| SUNDRY NOTICES AND REPORTS ON WELLS <i>Do not use this form for proposals to drill or to re-enter an abandoned well. Use Form 3160-3 (APD) for such proposals.</i> | | 5. Lease Serial No. NMNM0016331 |

| 1. Type of Well <input checked="" type="checkbox"/> Oil Well <input type="checkbox"/> Gas Well <input type="checkbox"/> Other | | 8. Well Name and No. CHAOS 34-33 WXY FED COM/1H |

Marathon Oil Permian LLC requests to make the following changes to the approved APD.

MARATHON OIL PERMIAN, LLC.
DRILLING AND OPERATIONS PLAN

SHEET 1 OF 3
JOB No. R4099_001
REV 2 JCS 3/17/2023

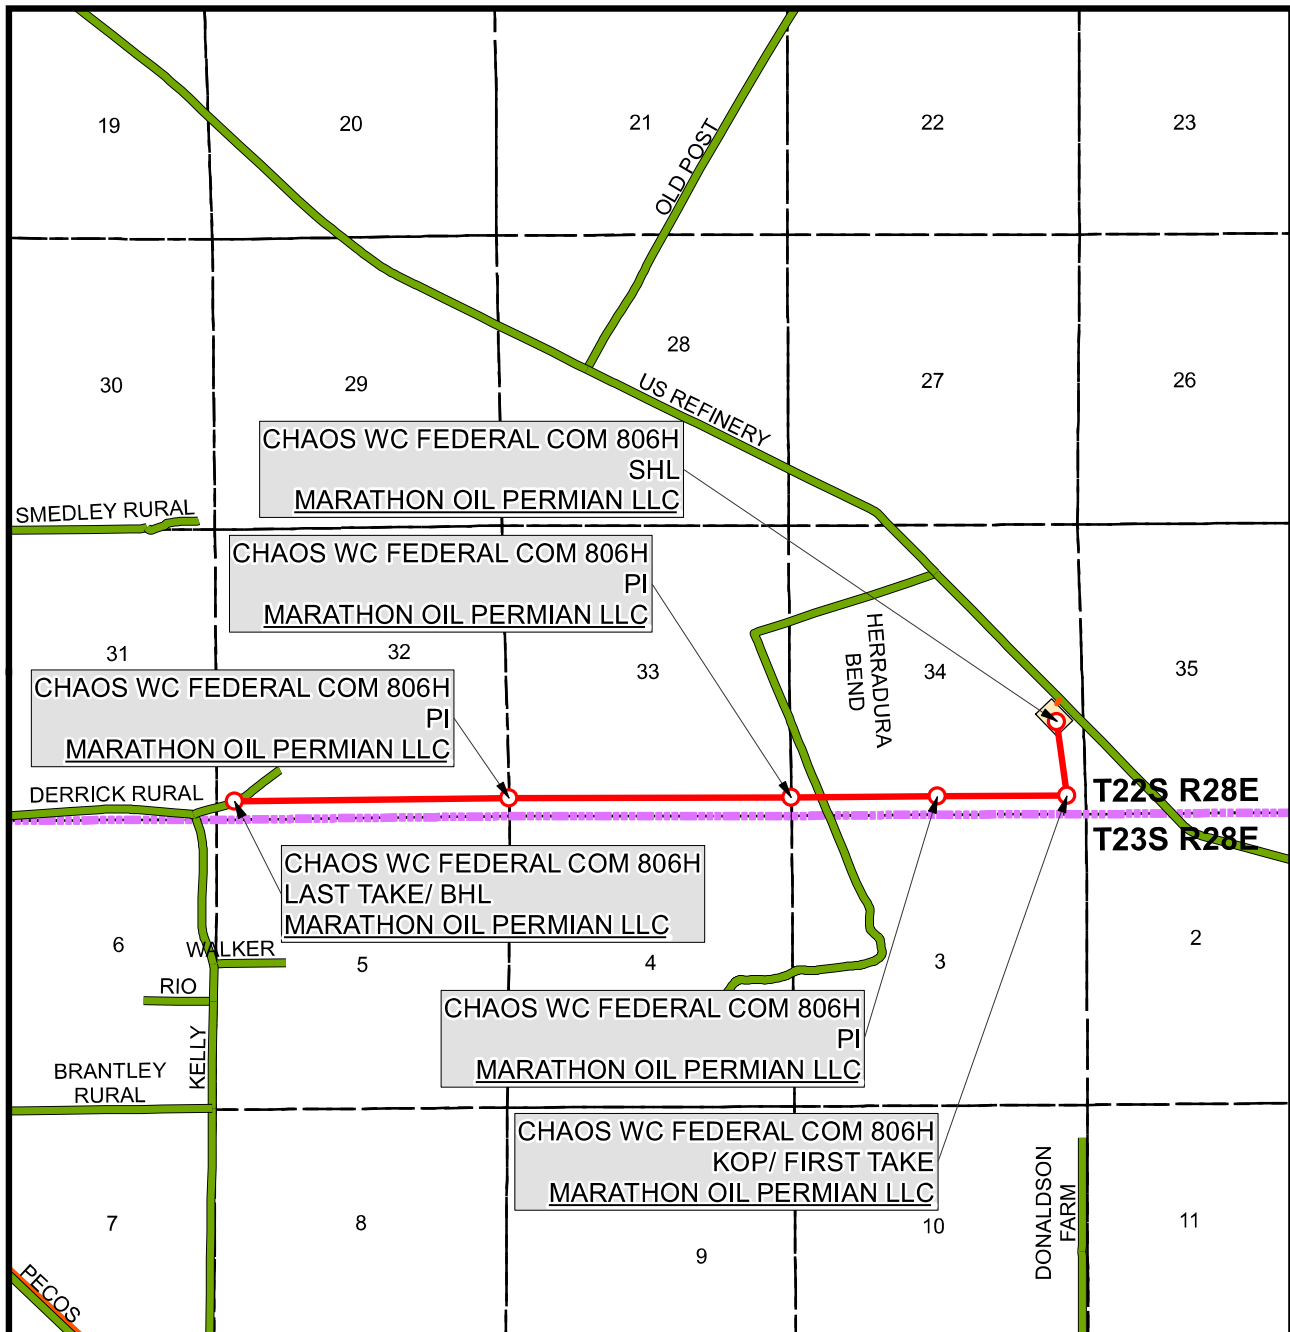
Well Name Change from Chaos 34-33 WXY Fed Com 1H to Chaos WC Federal Com 806H.

As well as BHL from 880 FSL to 330 FWL to 330 FSL to 330 FWL. Please see attached C-102, Drill Plan and Directional Plan.

**LAST TAKE POINT/
BOTTOM HOLE LOCATION**
330' FSL 330' FWL, SECTION 32
NAD 83, SPCS NM EAST
X: 608248.77' / Y: 488466.32'
LAT: 32.34267914N / LON: 104.11667275W
NAD 27, SPCS NM EAST
X: 567066.58' / Y: 488406.82'
LAT: 32.34255920N / LON: 104.11617483W

KICK OFF POINT/FIRST TAKE POINT
330' FSL 330' FEL, SECTION 34
NAD 83, SPCS NM EAST
X: 623398.43' / Y: 488569.00'
LAT: 32.34286760N / LON: 104.06761732W
NAD 27, SPCS NM EAST
X: 582216.04' / Y: 488509.32'
LAT: 32.34274697N / LON: 104.06712116W

SURFACE HOLE LOCATION
1681' FSL 475' FEL, SECTION 34
NAD 83, SPCS NM EAST
X: 623213.09' / Y: 489919.38'
LAT: 32.34658083N / LON: 104.06820663W
NAD 27, SPCS NM EAST
X: 582030.73' / Y: 489859.67'
LAT: 32.34646024N / LON: 104.06771032W
